# Central Falls High School

## 100% Construction Documents

Ai3 Project #2202.02

### **Addendum #3**

**MEDIA COMMONS ENLARGED PLAN AND INTERIOR ELEVATIONS - FOURTH FLOOR**

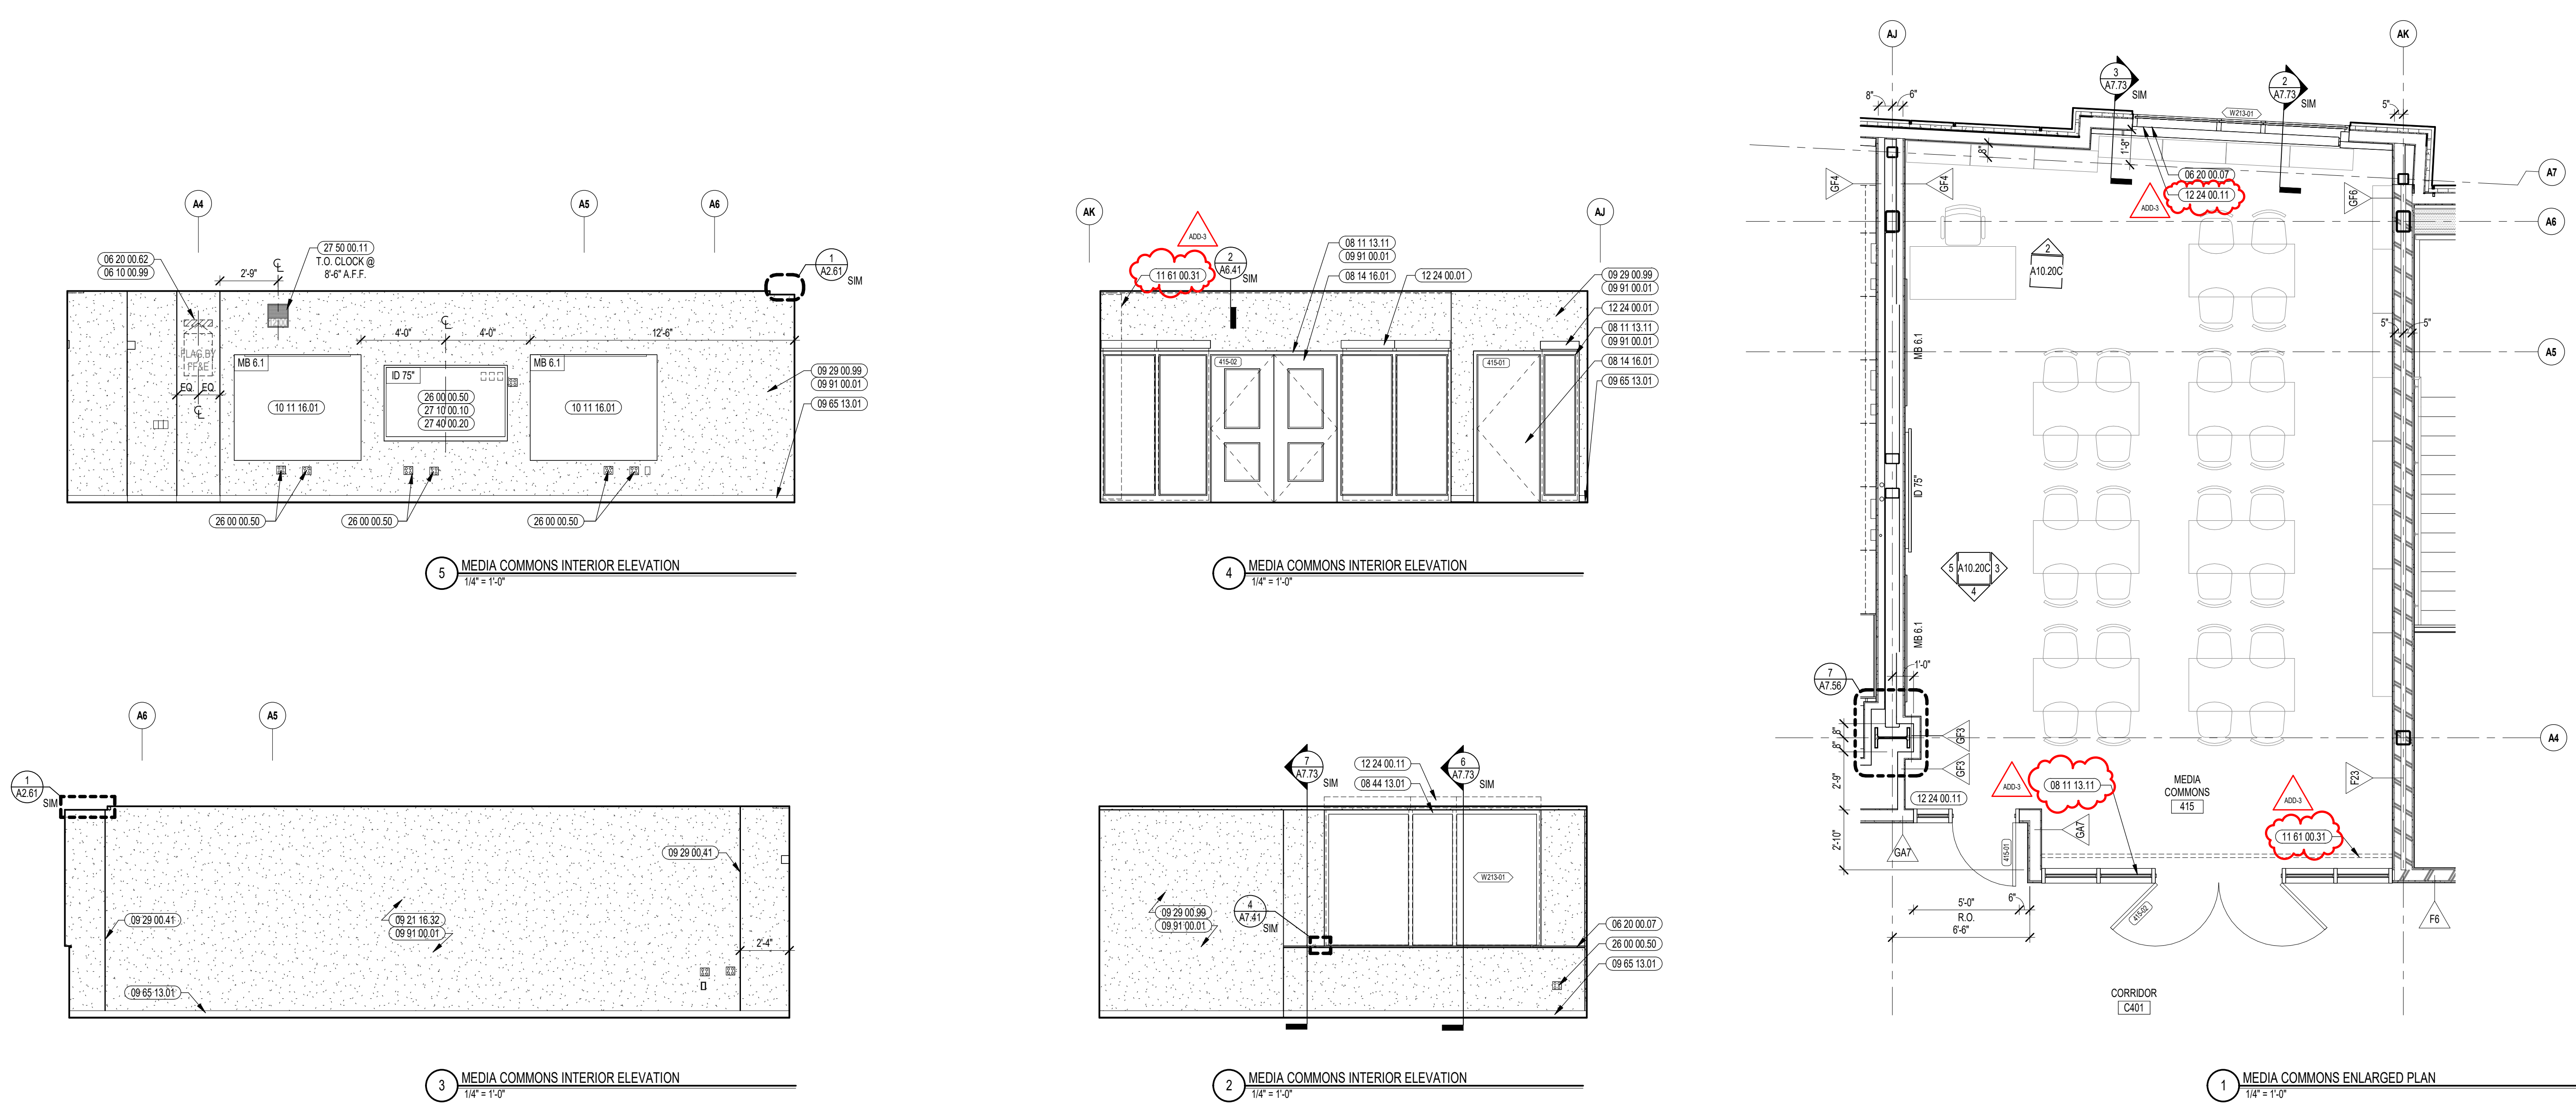
**ADD 3-002** **Bidder Question:** There doesn't seem to be drawings with Window Shade (Section 12 24 00) locations or any notes of the shades on the finished plans. The specs under part 2.1, they state there are roller shades manual, dual roller shades manual, blackout shades manual, and blackout shades motorized with locations for the blackout shades manual and blackout shade motorized. Where are these located? **Response:** Refer to opening details, interior wall sections, enlarged floor plans and elevations for keynoted shade

locations. See additional clarifications on A7.73, A9.25A, A10.20C and A10.41 in Addendum #3.
